DEVELOPMENT APPLICATION
New Independent Living Units
95 Stanhope Road, Killara
For Aevum Limited

TITLE Southwest - Basement + Roof Plan
SCALE 1:100 @ A1
DATE 15.10.10
DRAWN JK/CKH
CHECKED PT
0 1 5 10 metres

DWG NO
DA2.1

ISSUE **DATE** **AMENDMENT**
DA 25.06.10 For inclusion in Development Application
B 15.10.10 Council request for additional information
C 28.01.11 Council request for additional information

4 Western Elevation
1:100 @ A1

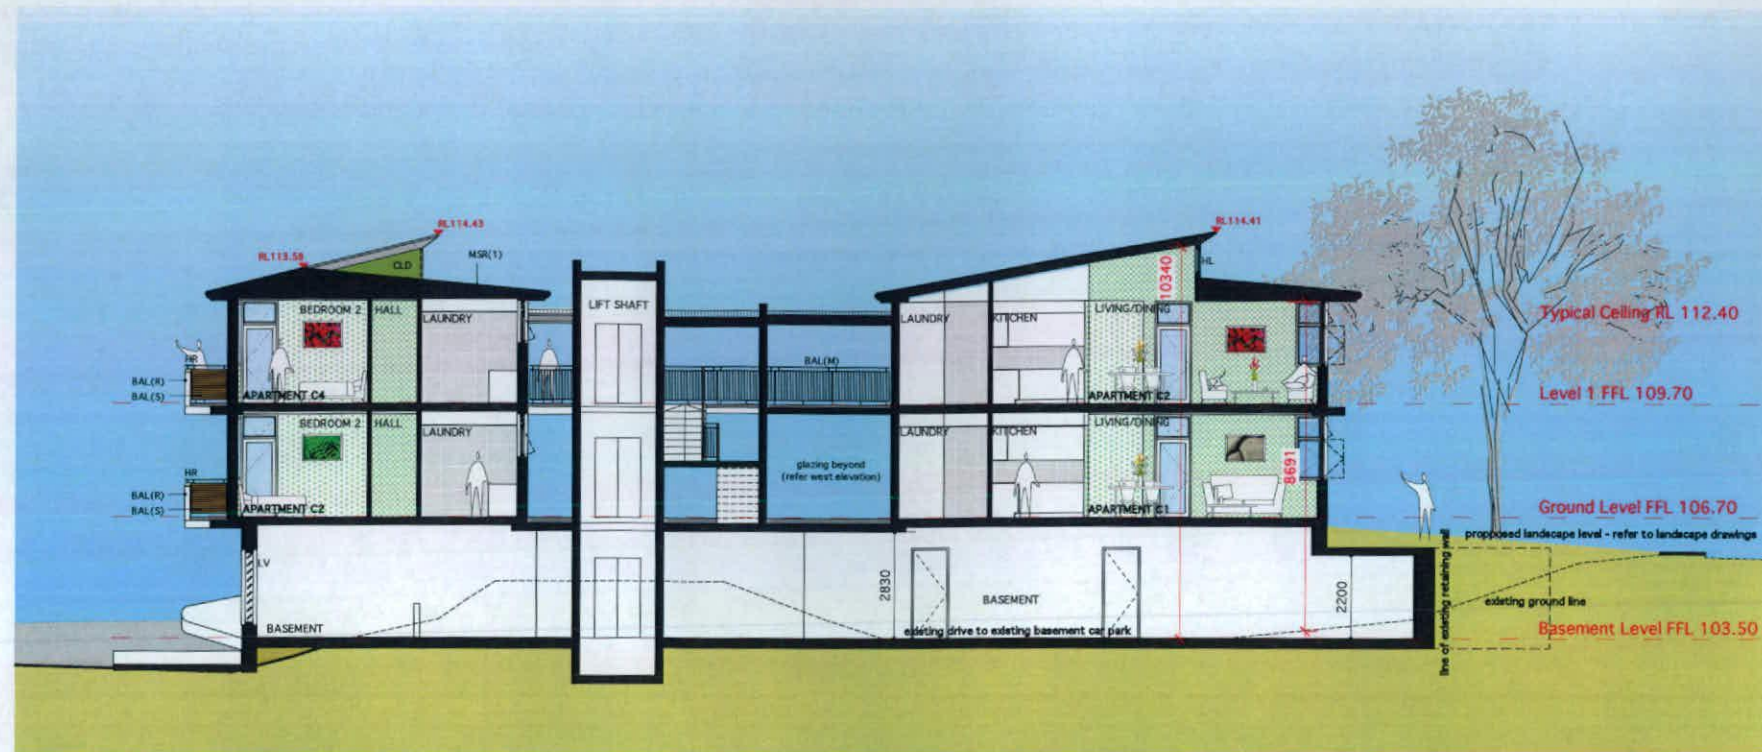
Amendments Western Elevation
1. Increased balcony size on unit C1

2 Section CB
1:100 @ A1

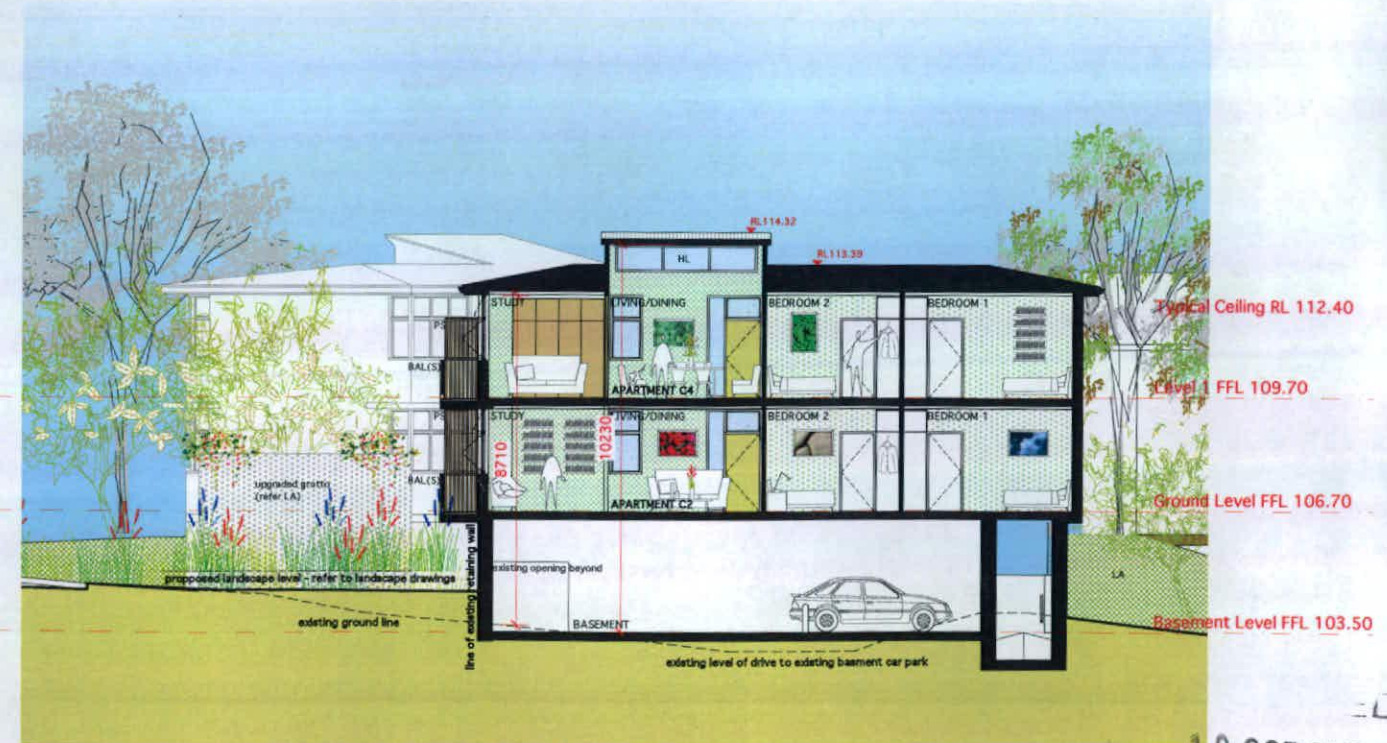
Amendments
1. Internal height dimensions added
2. Annotation re existing ground level added

Amendments
1. Internal height dimensions added
2. Annotation re existing ground level added

Amendments
1. Internal height dimensions added
2. Annotation re existing ground level added

4 Western Elevation
1:100 @ A1

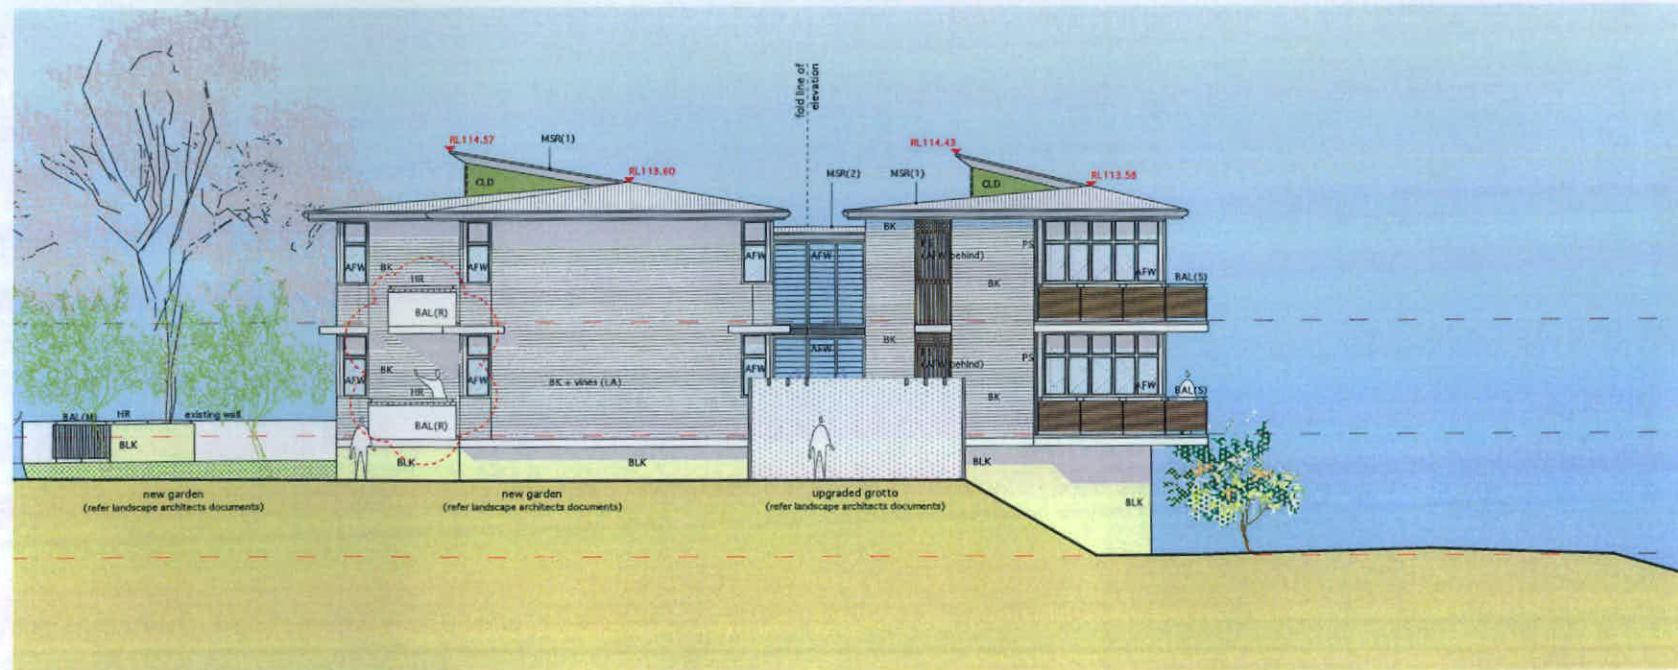
Amendments Western Elevation
1. Increased balcony size on unit C1

1 Courtyard Elevation
1:100 @ A1

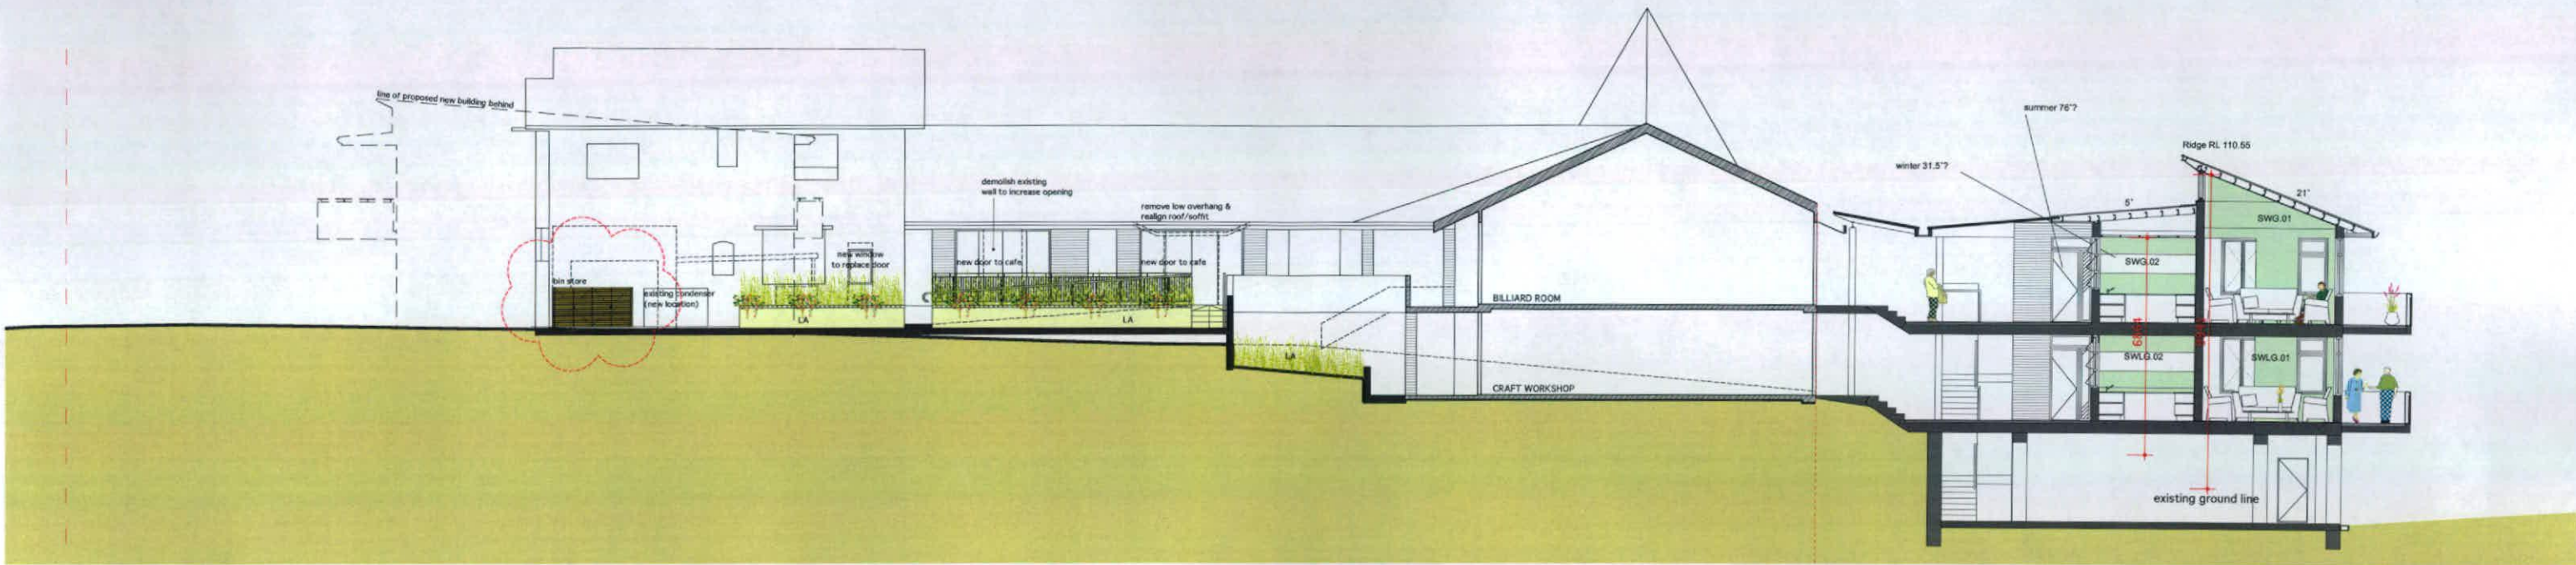
Amendments

1. Bin store added for cafe/admin waste
2. Proposed new window removed
